DCS1.Pilot v1.2 Errata sheet

Revision 1.0 (05/2024)

Important Updates and Corrections

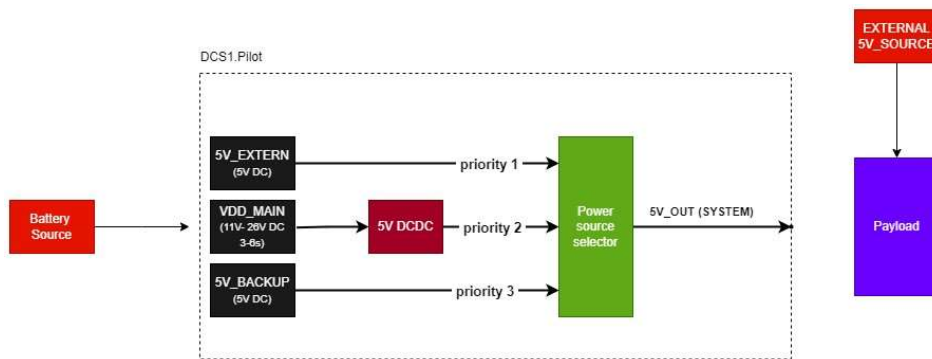
DCS1.Pilot v1.2 includes power selector circuit, which chooses one of three available prioritized sources for 5V line (respectively 5V_EXT, VDD_MAIN, 5V_BCKP). The respective source is considered valid if its voltage is within the range of 4.65V – 5.3V. Basically, if the bare DCS system is used, only VDD_MAIN supply rail is available. If the payload connected to board's 5V has behavior of capacitive load, so it can demand current spikes, voltage of the rail can fall below the undervoltage threshold and power selector disables this line. Following on that event, power selector tries to recover, but if transient current causes the peak again, 5V rail can remain disabled permanently.

1. Supply the payload and peripherals with significant power consumption from external power source.
